Wisconsin Department of Transportation

Proposal #18: 1130-64-76, WISC 2024306
Appleton – De Pere
Northland/STH 15 Intchg B440315/16
IH 041
Outagamie County

1130-64-81, WISC 2024229
Appleton – De Pere
Capitol Drive Overpass B440317
IH 041
Outagamie County

This is Addendum No. 03, which provides for the following:

Addendum No. 03
ID 1130-64-76
Revised Sheet 14
February 8, 2024

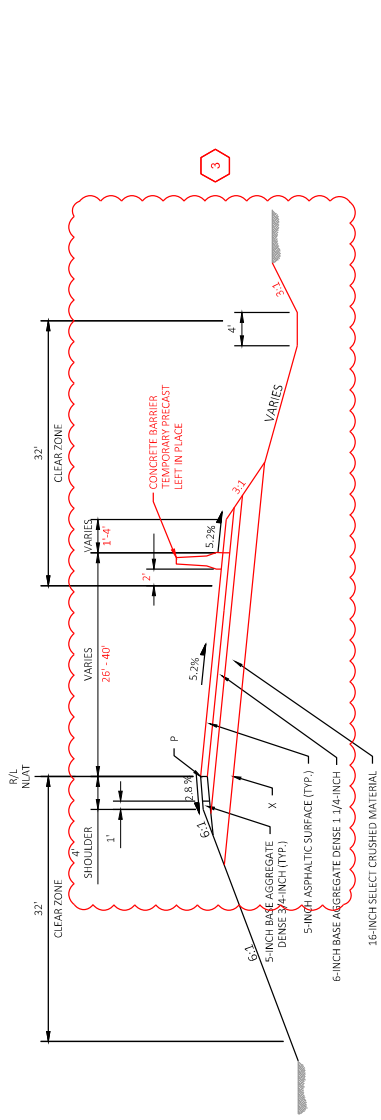
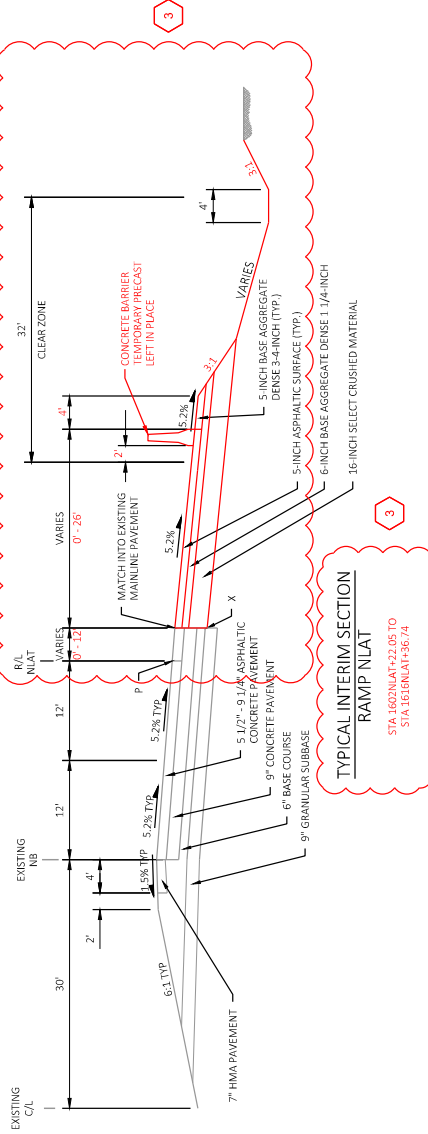
Revised Plan Sheets	
Plan Sheet	Plan Sheet Title (brief description of changes to sheet)
5 – 6	Updated NLAT (Interim Ramp A) linework
13	Removed concrete barrier from interim typical section
14	Updated NLAT (Interim Ramp A) typical sections
86	Updated Plan Details Legend. Added Concrete Curb Type G, Drilled Tie Bars
95 – 96	Updated temporary barrier linework
111 - 113	Updated NLAT (Interim Ramp A) linework
140-141	Updated temporary barrier linework
156 - 158	Updated NLAT (Interim Ramp A) pavement grades
208	Updated temporary barrier linework
215	Updated NLAT (Interim Ramp A) linework
218	Updated NLAT (Interim Ramp A) linework
223	Updated NLAT (Interim Ramp A) linework
293 – 294	Updated NLAT (Interim Ramp A) pavement markings
303 – 304	Updated NLAT (Interim Ramp A) pavement markings
342	Updated drums on Ramp D
357	Updated temporary barrier on Ramp D
358	Updated temporary barrier
377-378	Updated NLAT (Interim Ramp A) linework and Ramp D temporary barrier

Addendum No. 03
ID 1130-64-76/81
Added Sheet 40B
February 8, 2024

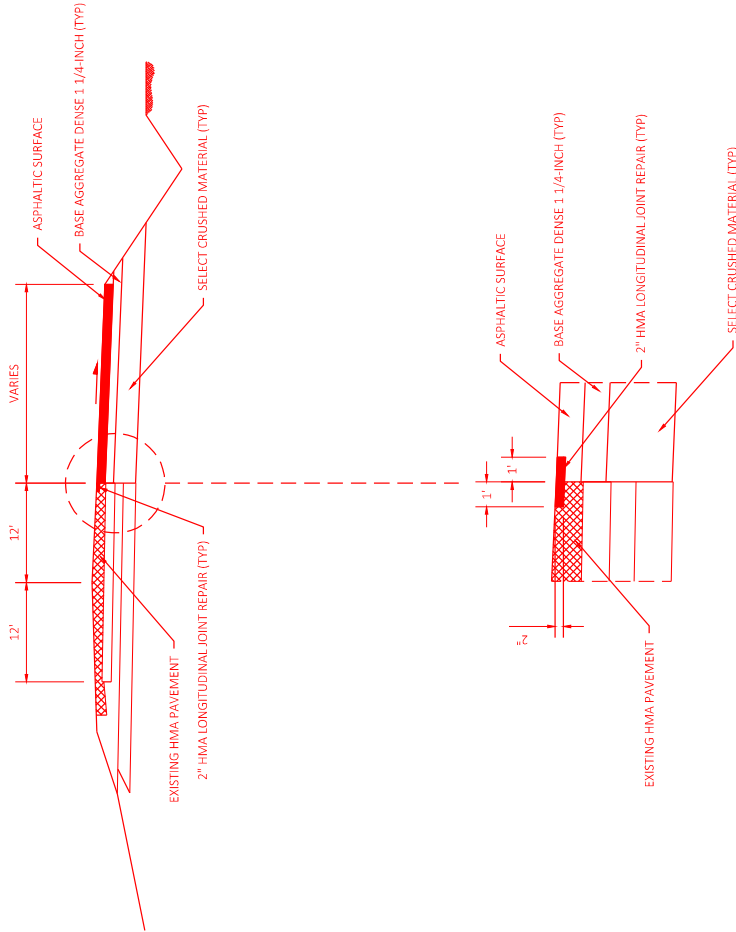
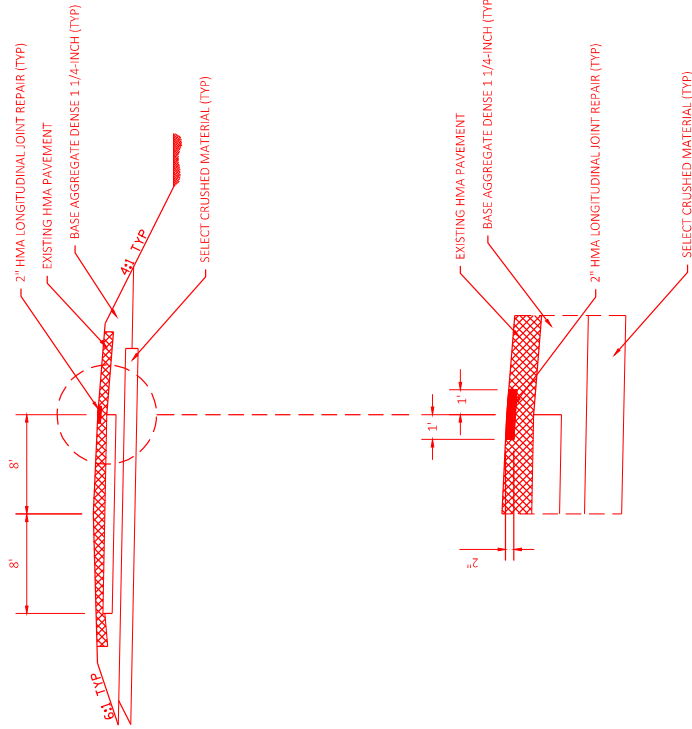
Added Plan Sheets	
Plan Sheet	Plan Sheet Title (brief description of why sheet was added)
40B	HMA Longitudinal Joint Repair Construction Detail
215A-215B	Erosion control sheet for NLAT (Interim Ramp A) and NLBT (Interim Ramp B)
401A	Typical Sections for Ramp D Stages 3A/3B/3C
957A	Road Name Aesthetic Details – Revised Road Name text details and parapet section details
996A	Road Name Aesthetic Details – Revised Road Name text details and parapet section details
1035A	Road Name Aesthetic Details – Revised Road Name text details and parapet section details

Addendum No. 03
ID 1130-64-76
Revised Sheet 629
February 8, 2024

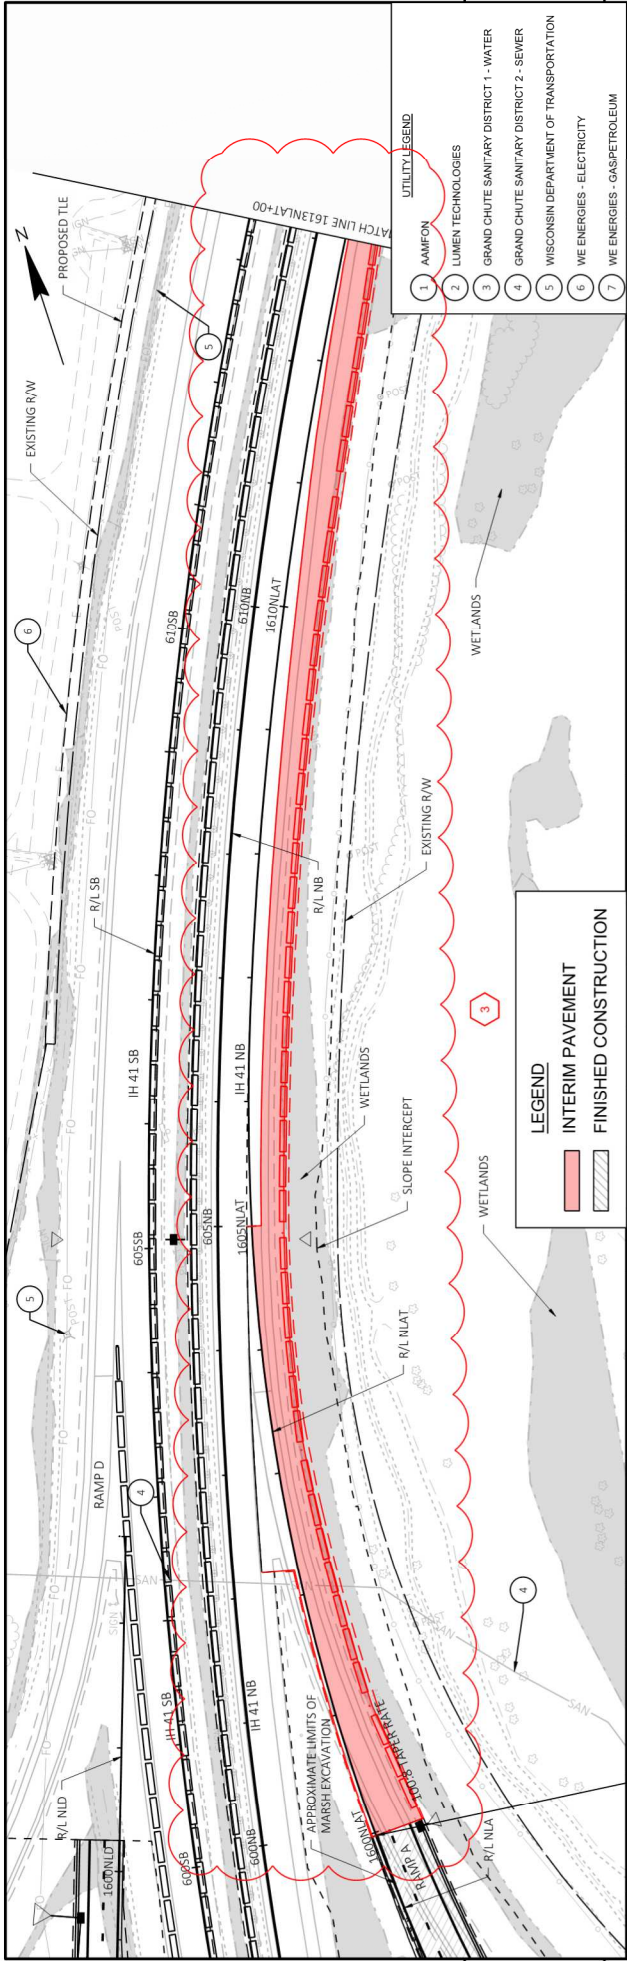
617	Updated NLAT (Interim Ramp A) linework on Plan and Profile.
629-630	Updated NLAT (Interim Ramp A) linework on Plan and Profile.
917	General Plan & Elevation – Revised List of Drawings
934	Pier Columns – Revised Reinforcement in Footing
953	Conduit Details – Updated details and added additional notes throughout sheet
956-957	Aesthetic Details – Revised Panel Dimensions and Post Spacing
958	General Plan & Elevation – Revised List of Drawings
960	Quantity – Revised Bid Item Quantity – 505.0400 Bar Steel Reinforcement HS Structures
974-975	Revised Reinforcement in Pier Footing
977	Pier Bill of Bars – Revised Pier Bar P809 and added B827
992	Conduit Details – Updated details and added additional notes throughout sheet
995-996	Aesthetic Details– Revised Panel Dimensions and Post Spacing
997	General Plan & Elevation – Revised List of Drawings
1034	Aesthetic Details (1 of 2) – Revised Road Name text details and parapet section details

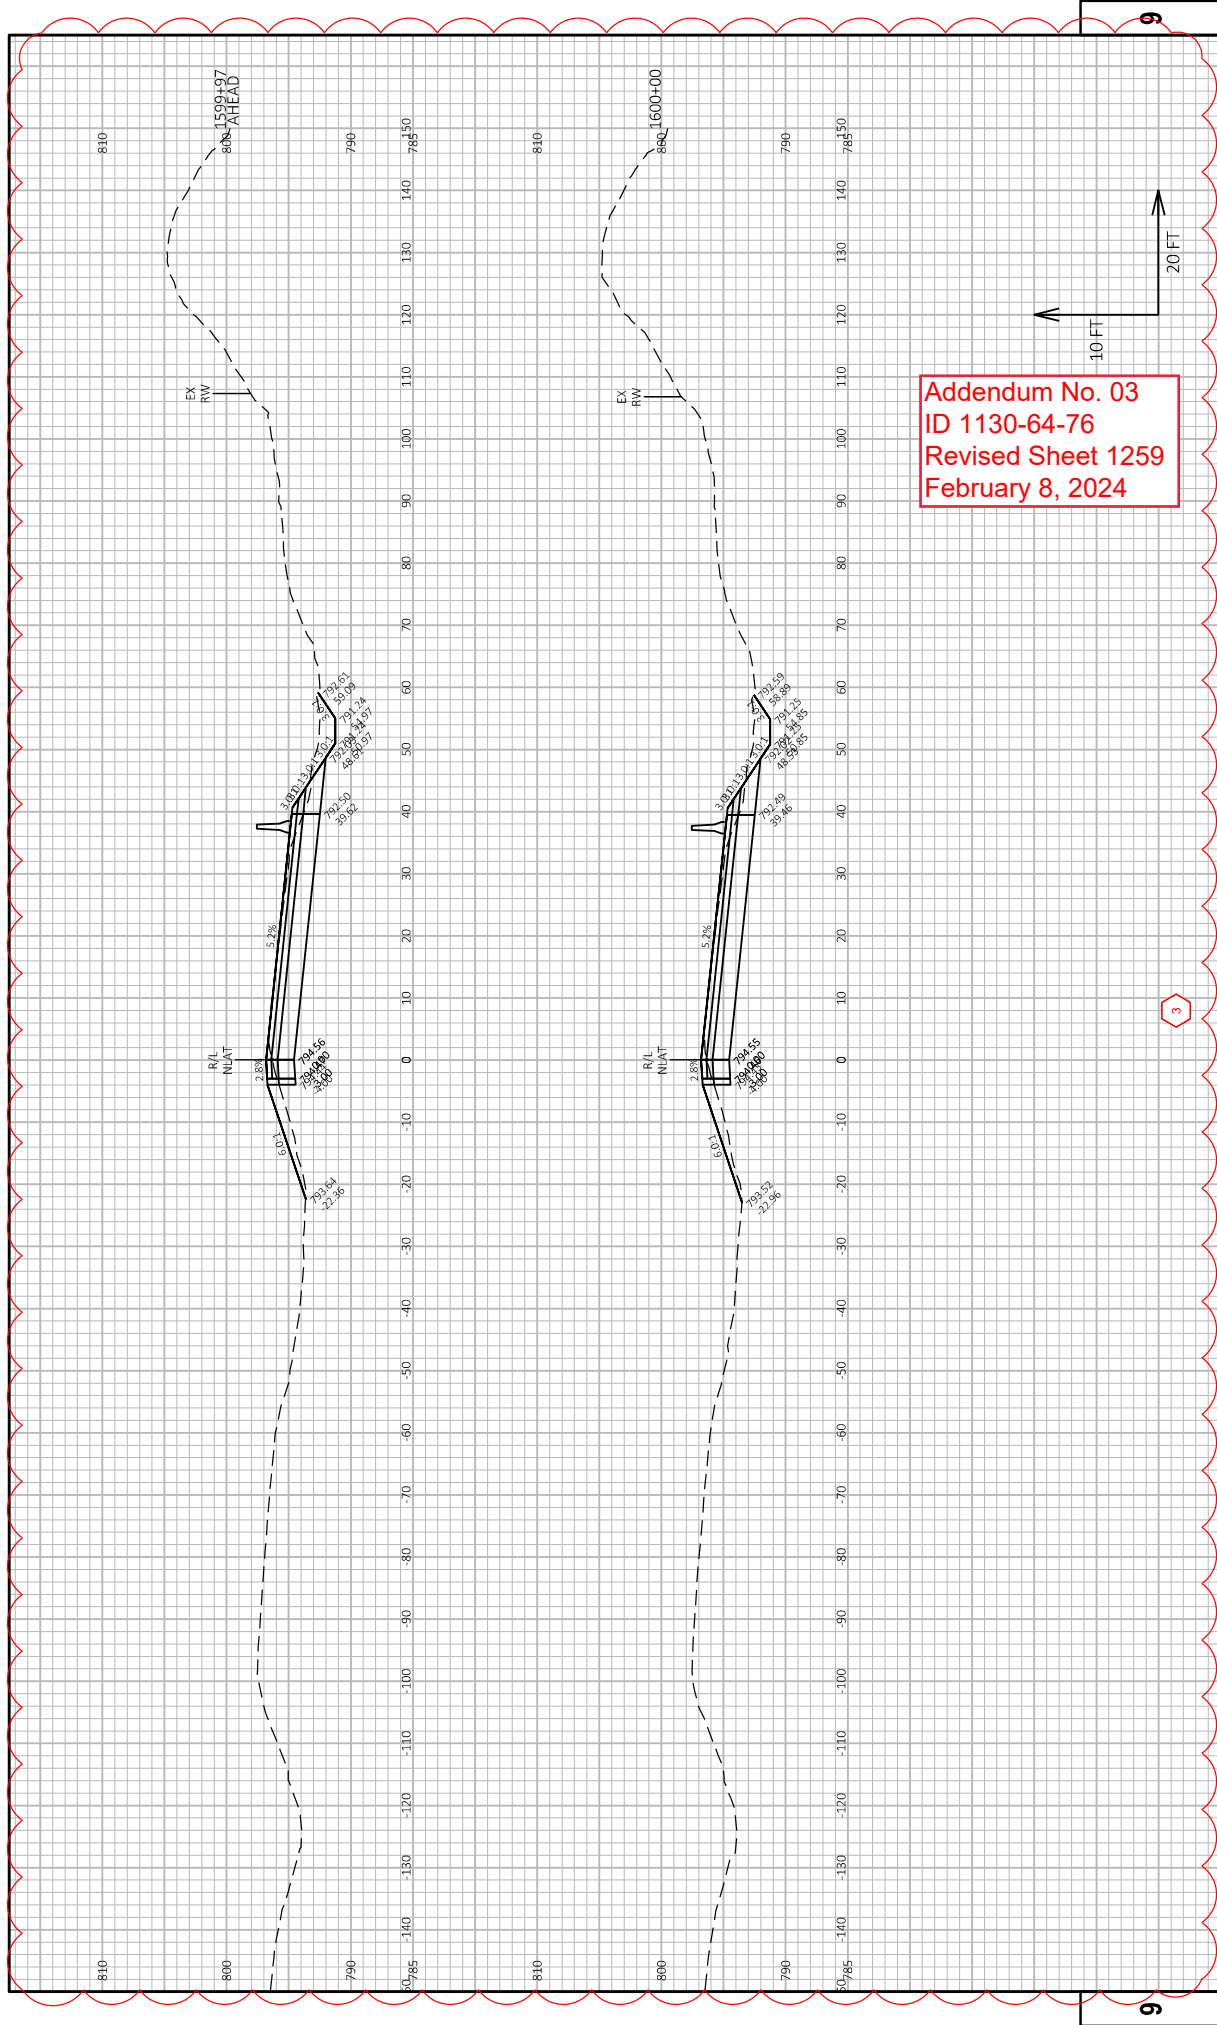
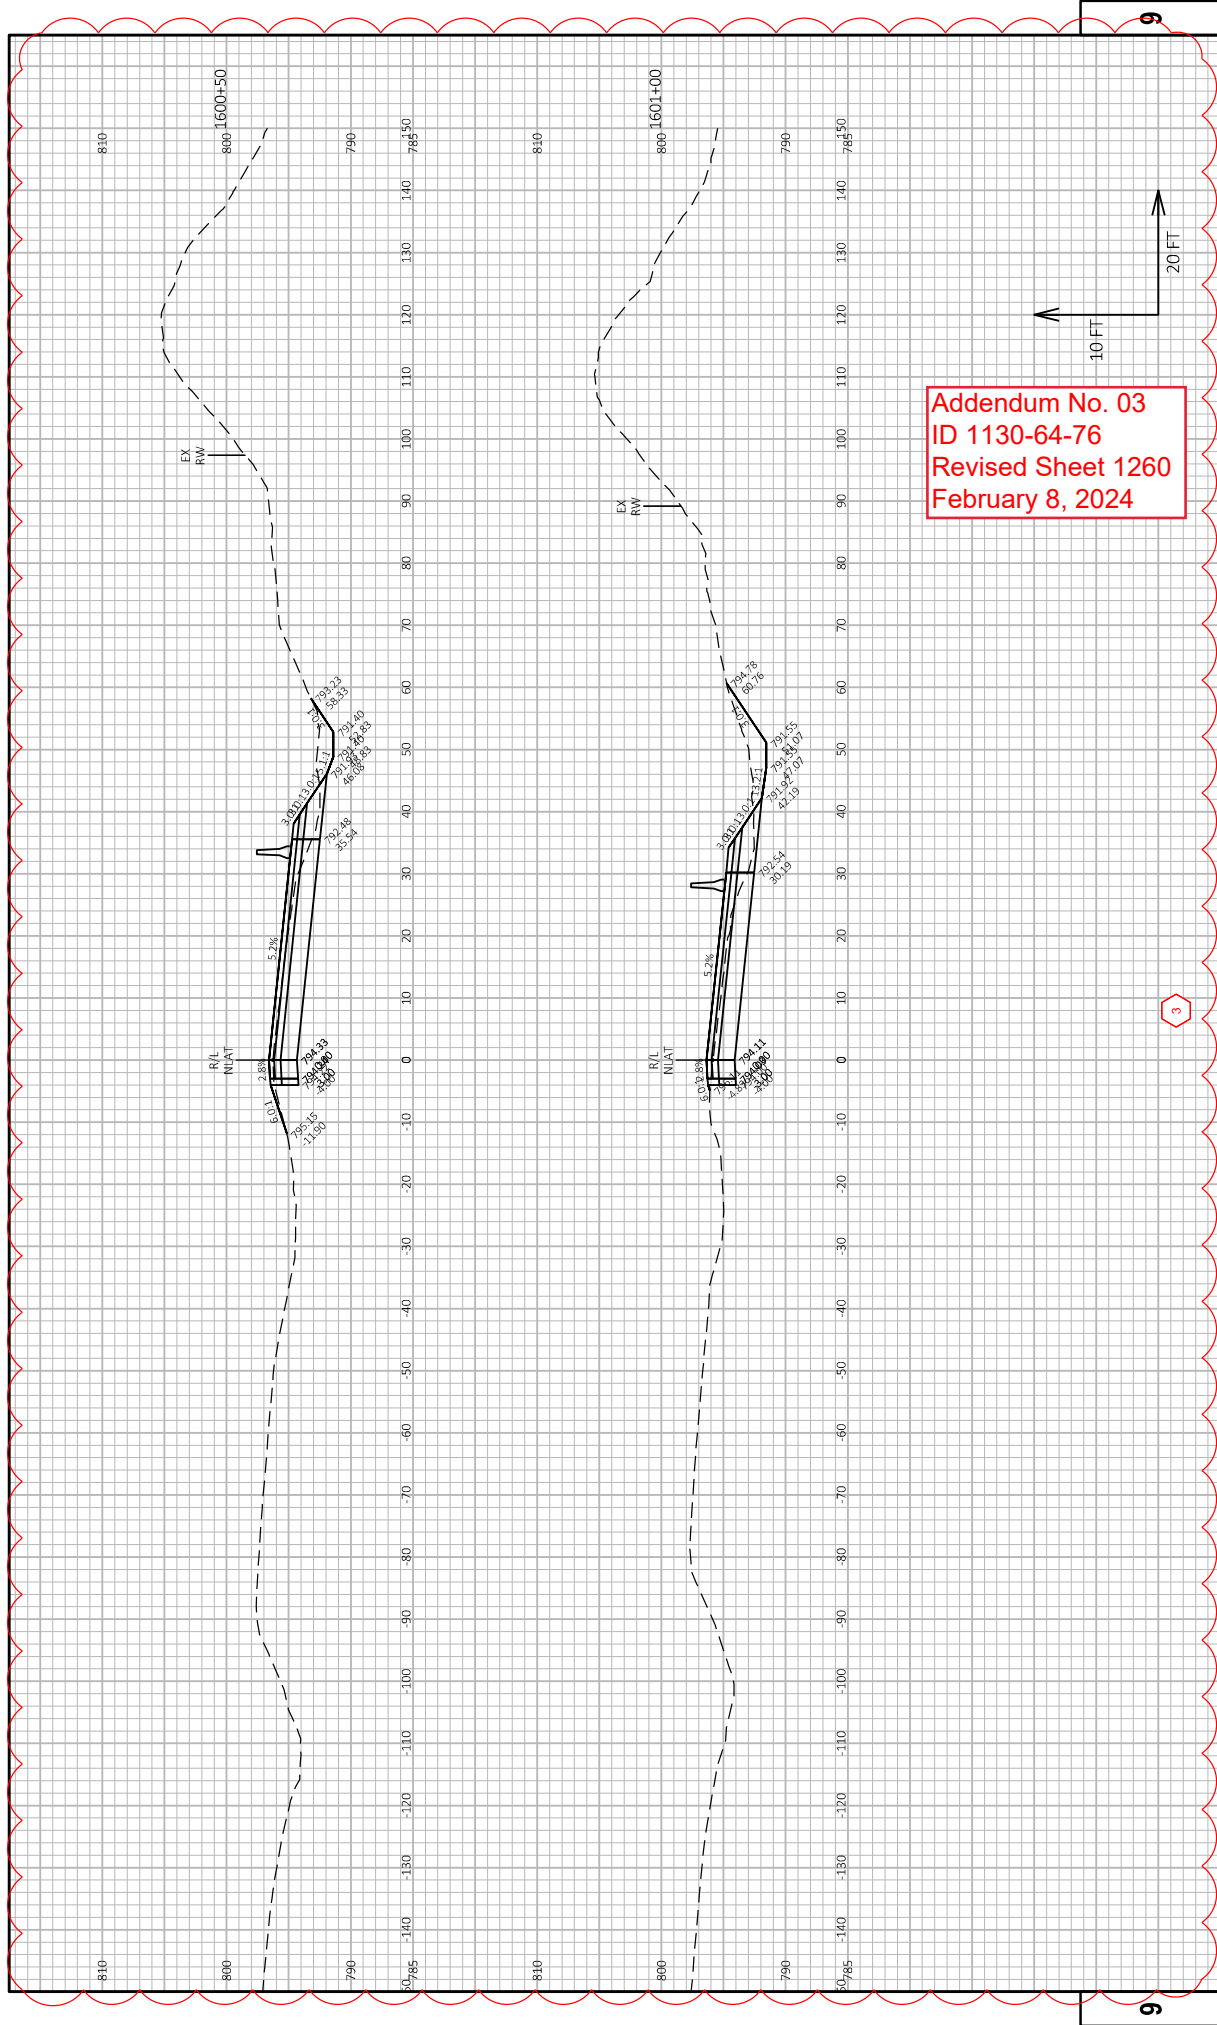
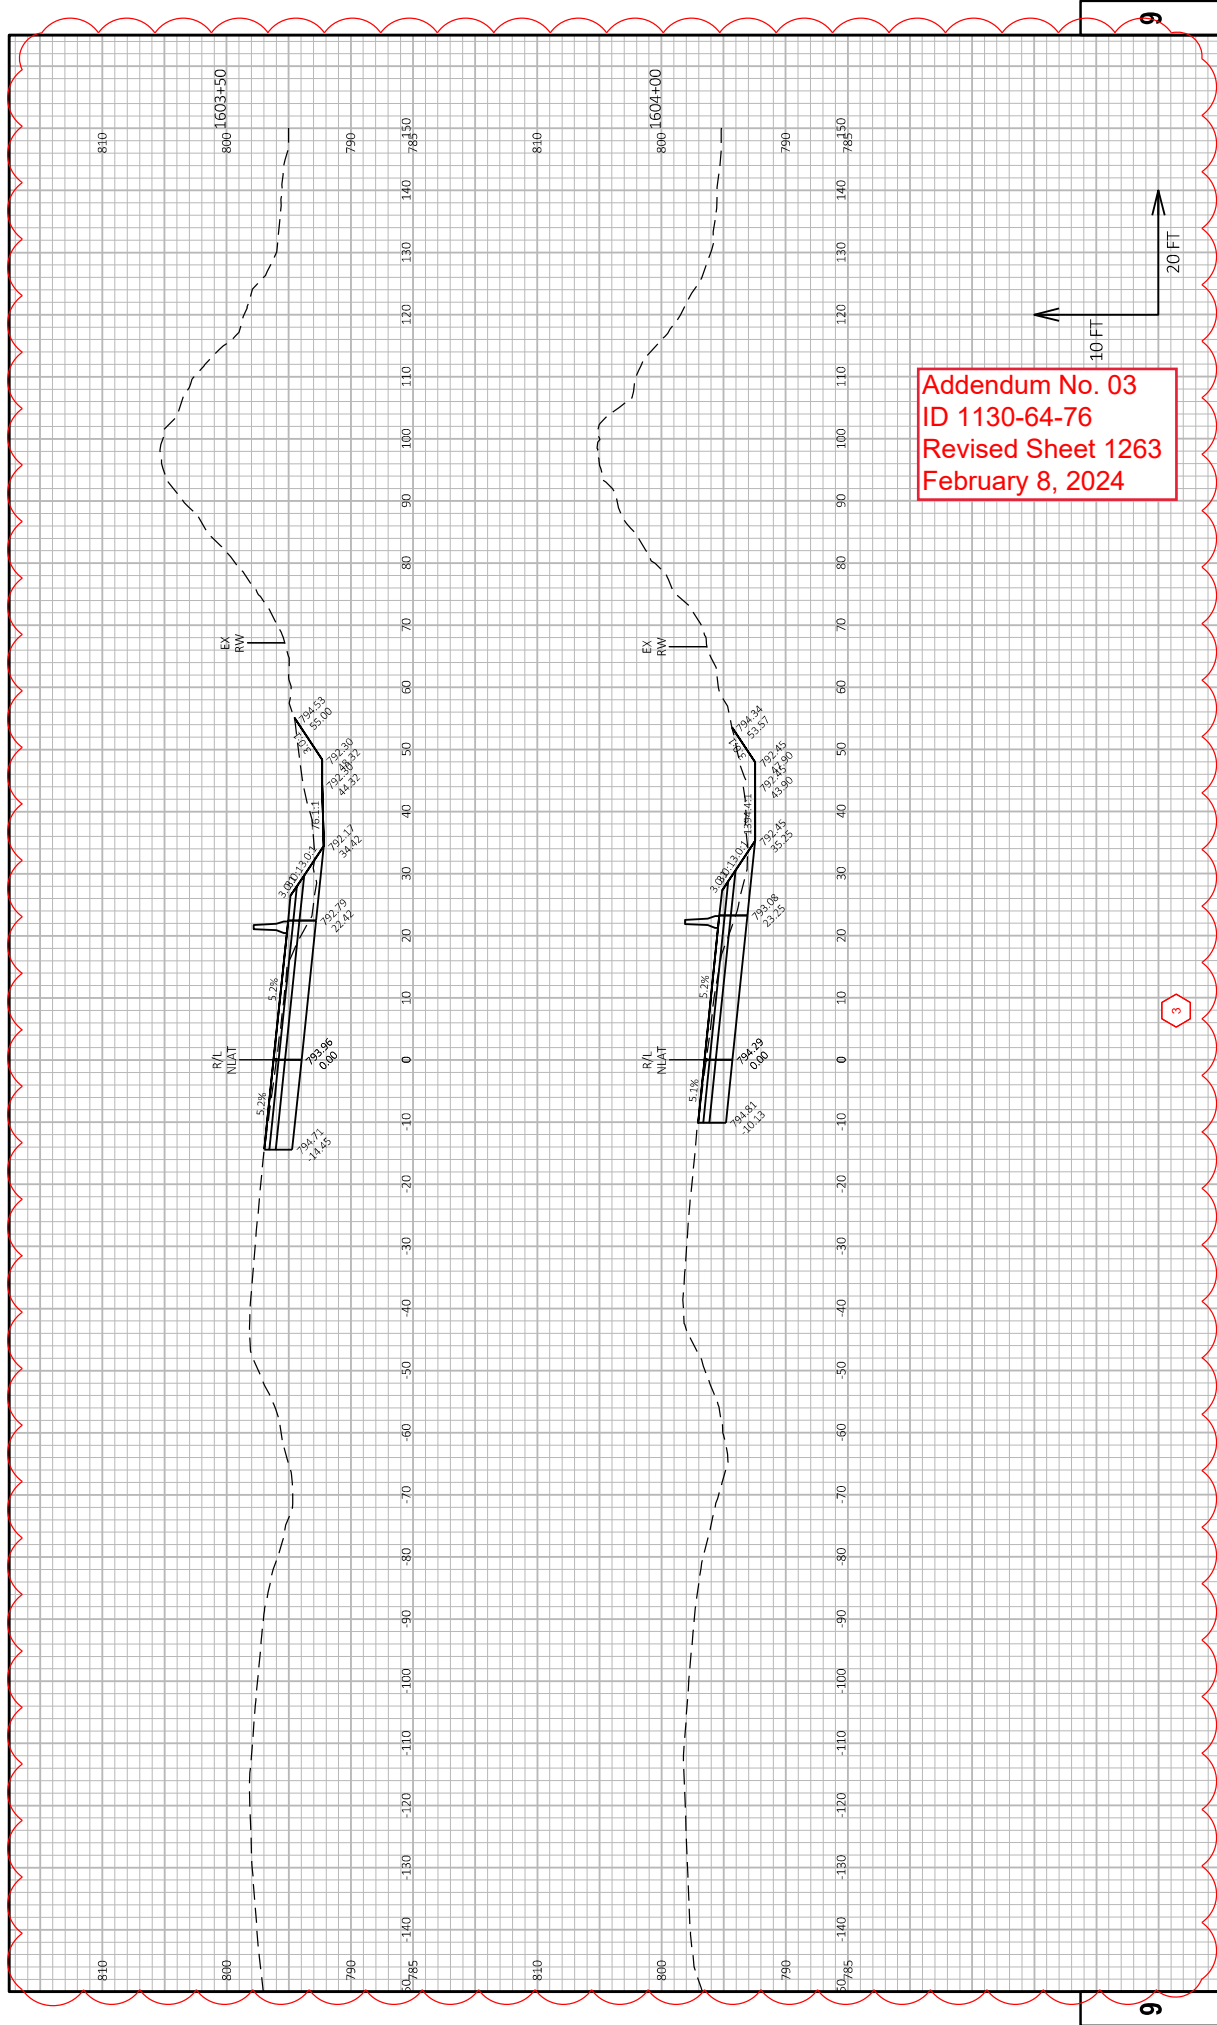
1099	Updated earthwork data for NLAT (Interim Ramp A)
1259 - 1276	Revised NLAT (Interim Ramp A) Cross Sections
